## **Thanet Extension Offshore Wind Farm**

### **Response to LPC Deadline 4C Submission**

Response to PLA / ESL Deadline 4C Submission

Response to POTLL / DPWLG Deadline 4C  
Submission

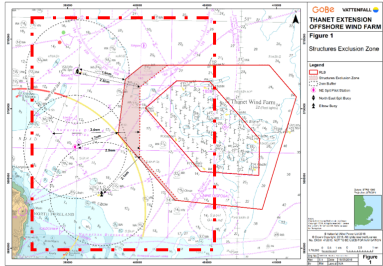
2.1.6 – 2.1.7	<p>From the limited time that the PLA and ESL have had to review the SEZ proposal, they understand that the exclusion would prevent the erection of wind turbine generators, meteorological masts, wind buoy and floating Lidar in the SEZ. However, according to paragraph 10 of Appendix 14 to the Applicant's Deadline 4 Submission, other activities "such as vessel manoeuvring, anchor handling and, jack-up barge placement will be possible, as well as cable laying. Any</p>	<p>The SEZ has been clearly defined and identified in the SEZ Paper and is a standard approach, used for other projects (Ref: REP4-018, Appendix 14 to Deadline 4 Submission).</p> <p>The purpose of the SEZ is to provide additional sea room for shipping and navigation. A workshop on 27 Feb was held with all interested parties to identify sea room requirements – however no proposals were made by IPs on geographic layout or absolute spatial requirements.</p>

<p>other long-term (but moveable) structures as requested by the relevant authorities, such as demarcation buoyage will be permitted.” It appears that other works, including structures such as substations and cabling, and other activities, including maintenance, would still be permitted and the PLA and ESL would welcome the opportunity to clarify this with the Applicant.</p> <p>The amount and types of activity which would still be permissible within the SEZ mean that the majority of the PLA and ESL’s concerns about sea room remain. It would seem that all ancillary works under the DCO would still be permitted in the SEZ. This covers a wider array of activities including the placing of temporary landing places/moorings for construction and maintenance. The PLA and ESL are concerned about any potential encroachment into the available sea room.</p>	<p>The Applicant has provided a detailed submission in response to the ISH8 Action Points regarding the activities that may be carried out within the SEZ at Appendix 7 (Annex A) to this Deadline 5 submission.</p>

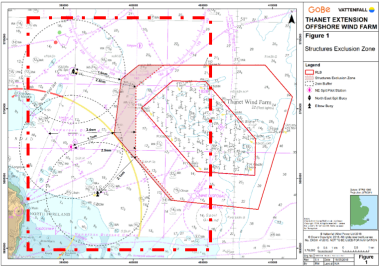
3.10	The PLA’s and ESL’s detailed comments on the NRA addendum are at Appendix 3.	See below.
3.11	The PLA and ESL have also prepared a joint revised risk assessment which is included here at Appendix 4. The scoring for the PLA/ESL risk assessment is based on a similar methodology to that used by Marico Marine and uses a combination of most likely and worst credible outcomes. However, the likelihood is scored using a 1-5 matrix, and multiplied by the	The Applicant notes that the PLA / ESL use the same hazards identified as part of the Addendum NRA and are therefore must be agreed by the PLA.  The Applicant would also note that there is very little supporting methodological information contained with regards to the PLA / ESL NRA included in Appendix 4, including

<p>The Applicant also notes that the Tilbury 2 <a href="#">NRA</a> (applies a similar PLA methodology – but with an action key analogous to the PLA Navigational Risk Assessment Pro-forma recorded higher risk scores in their DCO submission for their “Inherent” (12/25 – high risk) and “Residual” (9.2/25 – Haz ID 14) assessment of risk than PLA / ESL NRA Addendum risk assessment does.</p> <p>Comparison of NRA input consequence scores between the PLA / ESL NRA Addendum input scores shows minimal differences in hazard baseline consequence scores for the Most Likely consequence scores (81% of the 72 scores consequence input scores for the 18 hazards remained the same) and there is an even smaller differences for the Worst Credible assessment (97.2% of consequence scores for worst credible remained the same).</p>	ACTION KEY	Slight (1 – 2)	No Action is required		Minor (3 – 4)	No additional controls are required, monitoring is required to ensure no changes in circumstances		Moderate (5 – 9)	Efforts should be made to reduce risk to ‘As low as reasonably practicable’ (ALARP), but activity may be undertaken		High (10 – 14)	Efforts should be made to reduce risk to ‘As low as reasonably practicable’ (ALARP). Activity can only be undertaken with further additional controls.		Extreme (15 – 25)	Intolerable risk. Activity not authorised
ACTION KEY	Slight (1 – 2)	No Action is required															
	Minor (3 – 4)	No additional controls are required, monitoring is required to ensure no changes in circumstances															
	Moderate (5 – 9)	Efforts should be made to reduce risk to ‘As low as reasonably practicable’ (ALARP), but activity may be undertaken															
	High (10 – 14)	Efforts should be made to reduce risk to ‘As low as reasonably practicable’ (ALARP). Activity can only be undertaken with further additional controls.															
	Extreme (15 – 25)	Intolerable risk. Activity not authorised															
3.1.3	<p>Both the PLA and ESL want to continue to work with the Applicant in seeking a solution suitable for all parties involved. The SEZ as proposed by the Applicant is insufficient in its geographical extent and would still permit activities and works to be carried out within the SEZ which would pose a risk to ESL’s and the PLA’s operations</p>	<p>The Applicant remains committed to working with PLA/ESL to seek a solution and common ground. However the Applicant notes that the PLA and ESL state the geographical extent of the SEZ is not sufficient, and the Applicant remains unclear on the expectation the PLA / ESL have in the extent of any geographical change they propose to the SEZ.</p> <p>The Applicant is willing to clarify any point the PLA / ESL have in regard to use of the SEZ and work with PLA / ESL to accommodate any concerns they may have on the details of the SEZ.</p>
